Record of Decision Operable Units 3, 4, and 5 Lower Fox River and Green Bay, Wisconsin

Record of Decision Responsiveness Summary

SUPERFUND RECORD OF DECISION (ROD)
for Operable Units 3, 4, and 5
Wisconsin DNR and U.S. EPA
Lower Fox River and Green Bay
Brown, Door, Marinette, Oconto, Outagamie, Kewaunee, and Winnebago Counties,
Wisconsin, and
Delta and Menominee Counties, Michigan
CERCLIS ID: WID000195481
June 2003

Figure 1 Graphical Representation of Lake Winnebago Stages Comparing 2003 Levels vs. 2002 Levels in feet, Oshkosh

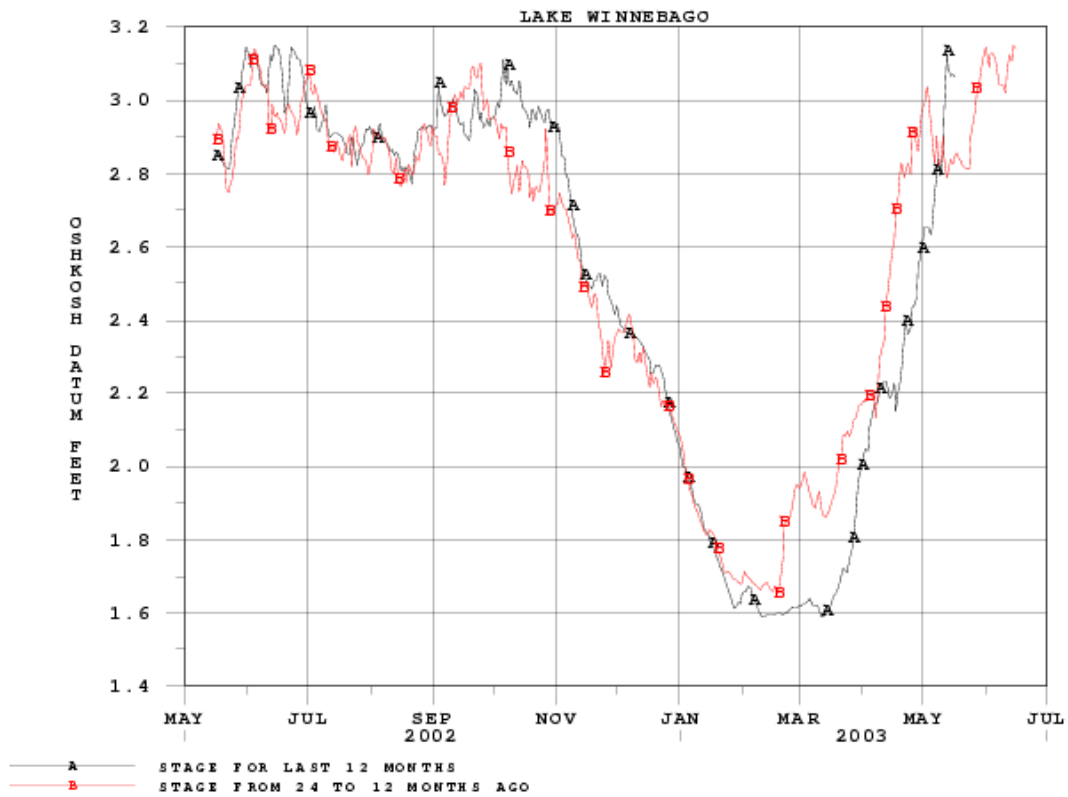
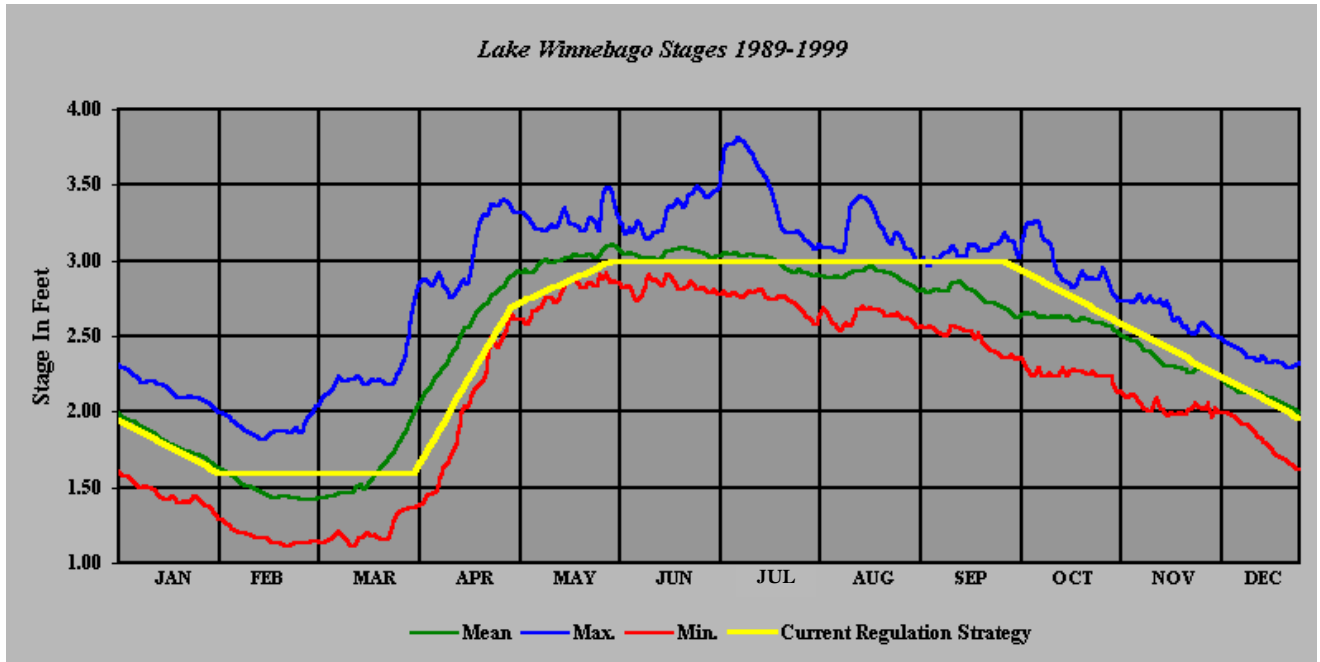
Flooding of the Lower Fox River generally requires several days to develop. The graphical representations in Figures 1 and 2 from the USACE website (http://www.lre.usace.army.mil/index.cfm?chn_id=1072#Flood) indicate increases in the outflow of Lake Winnebago. Note that in the 1998 to 1999 period, maximum outflow for July indicates an event in which large water volume releases occurred from Lake Winnebago in an abrupt discharge, which suggests concern for flooding and excessive erosive force in the Lower Fox River.

FIGURE 3 RESULTS OF METHOD TEST; PCB MASS (0 TO 1 CM) AS A RESULT OF SEDIMENT BULK DENSITY AND PCB CONCENTRATION INTERPOLATED SEPARATELY

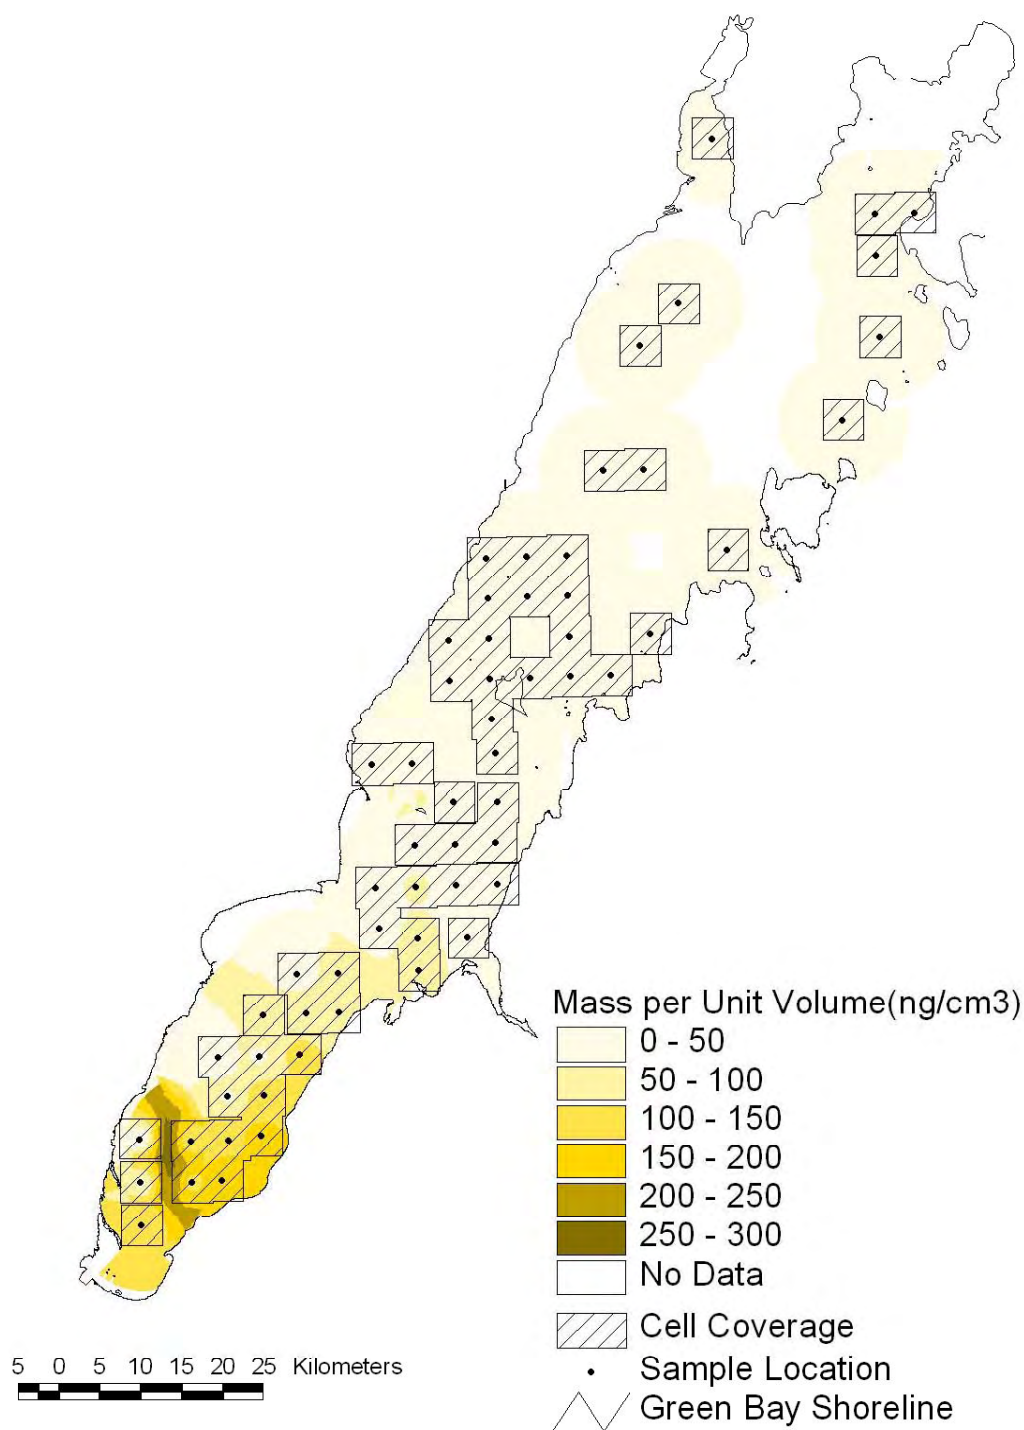
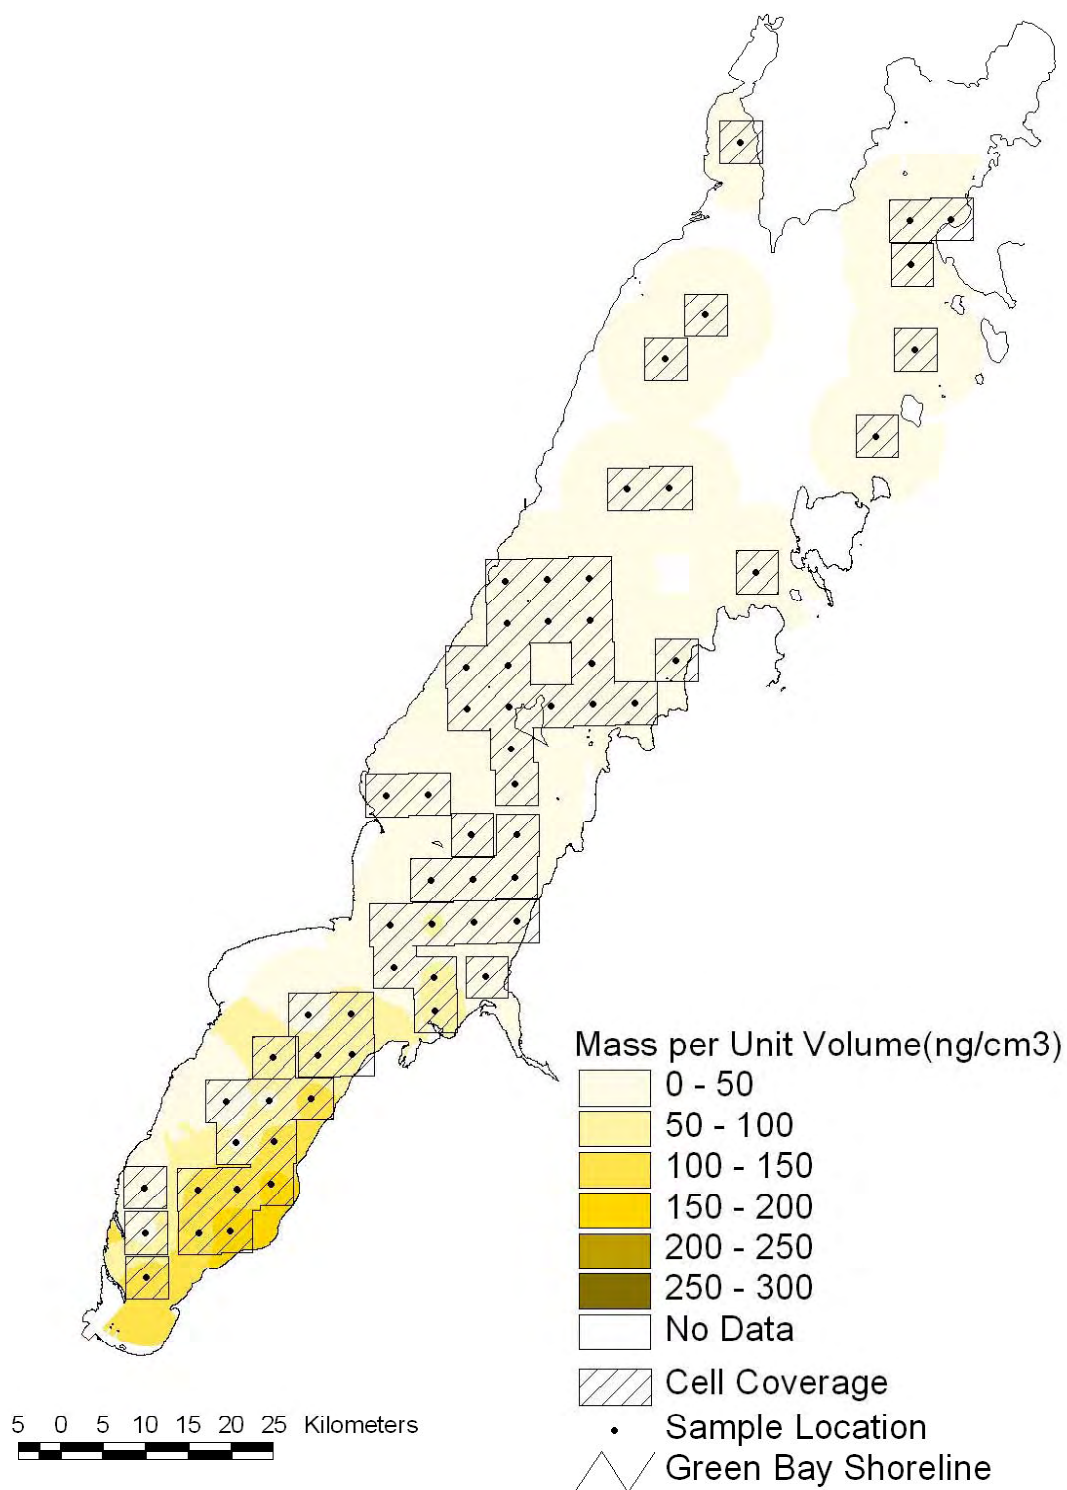
The interpolation method evaluation test produced an initial map coverage of PCB mass estimates for the top (0 to 1 cm) layer of sediment in Green Bay (Figure 3) as well as a quantitative summary of total PCB mass (Table 2). When compared to the mapped mass results generated by the UW, the WDNR map displays a “saddle” of high PCB mass in an area located between relatively low PCB concentration and high bulk density measurements. This phenomena is an artifact of the IDW interpolation. Further analysis confirmed that, by multiplying together interpolated values of PCB mass and bulk density, the IDW approach could result in PCB mass estimates between cores that are higher than the bounding known PCB mass values. Figure 3 displays a “saddle” artifact in the southern portion of the Bay. Quantitatively, this artifact accounts for a 14 percent difference (increase) in PCB mass compared to that put forth by the UW (Table 2).

The results of the method evaluation test show that differences in UW's mass estimate and the mass estimate and contaminated sediment volume presented in TM 2f can not be attributed to the IDW interpolation algorithm.

FIGURE 8 TM 2F ALTERNATIVE APPROACH; PCB SURFACE CONCENTRATIONS (0 TO 2 CM)

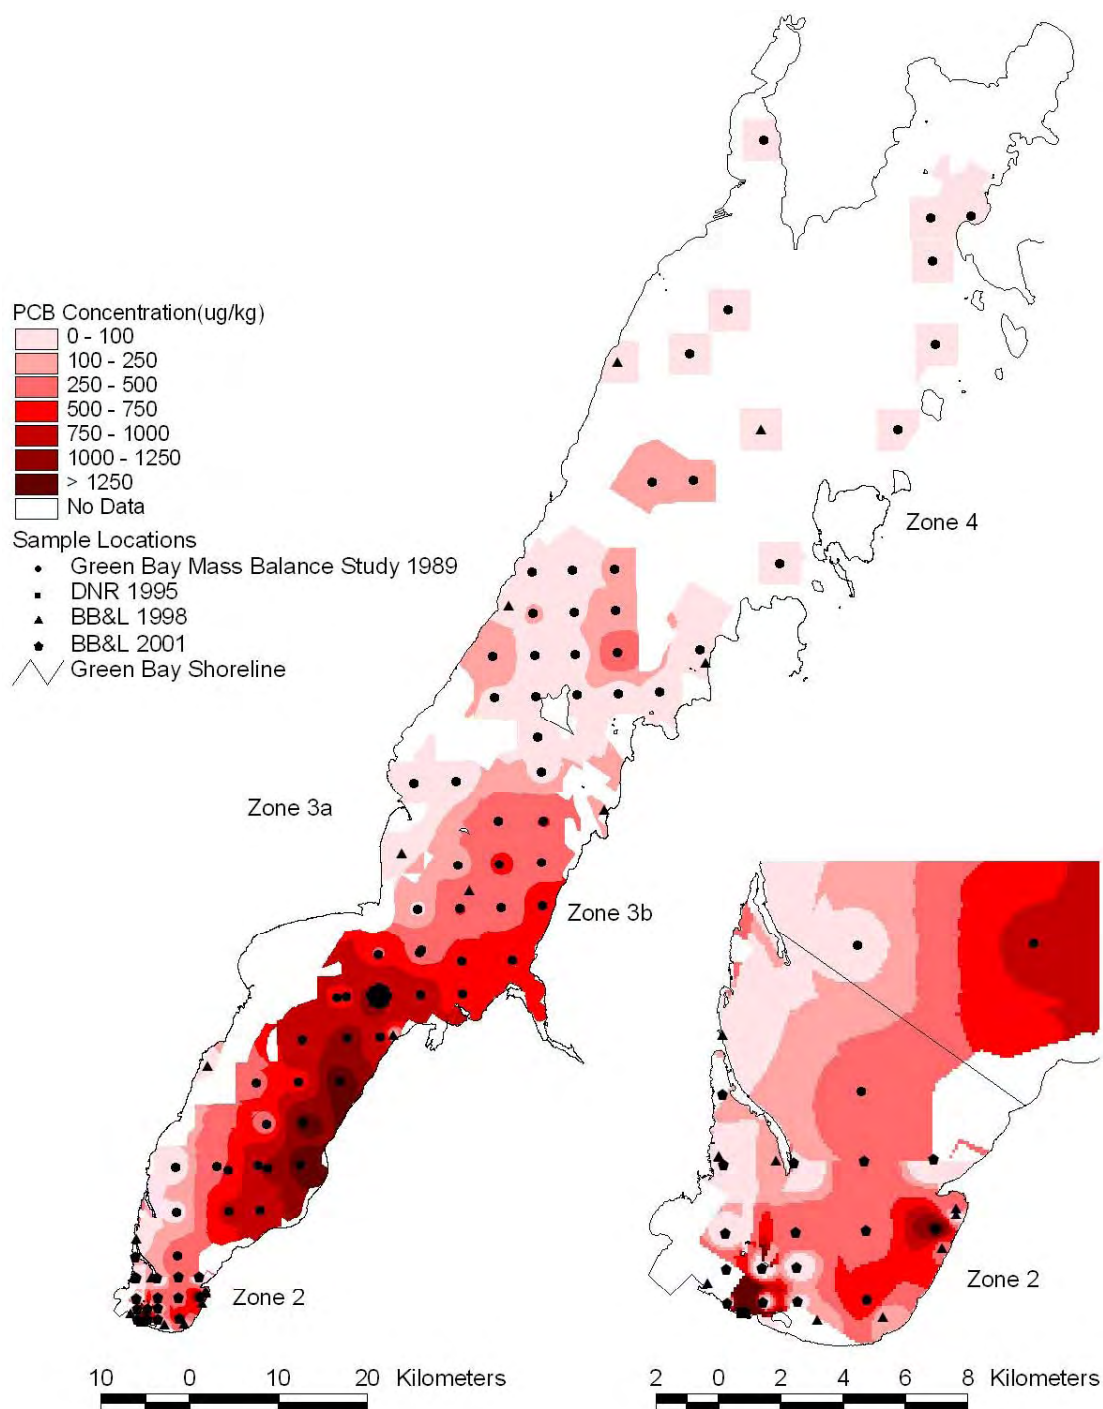
Figure 8 is a map of Green Bay depicting the interpolated results of PCB concentrations in the top layer (0 to 2 cm) of sediment. It is important to note that, compared to the PCB concentration maps presented in TM 2f (Figure 5-7), the revised concentration estimates differ only slightly overall. In the north Bay (zones 3A, 3B, and 4), concentration

Table 8 is based on Figure 8 and provides a comparison of PCB surface concentrations in the top layer (0 to 2 cm) of sediment using the TM 2f approach and the alternative method. The revised concentration estimates in the north Bay (zones 3A, 3B, and 4) have similar magnitudes and remain essentially the same using the alternative method while in the south Bay (Zone 2) there is a reduction in the concentration. This difference in Zone 2 is due to a bounding affect on the interpolation caused by the shallow and low-concentration PCB data in the south Bay.
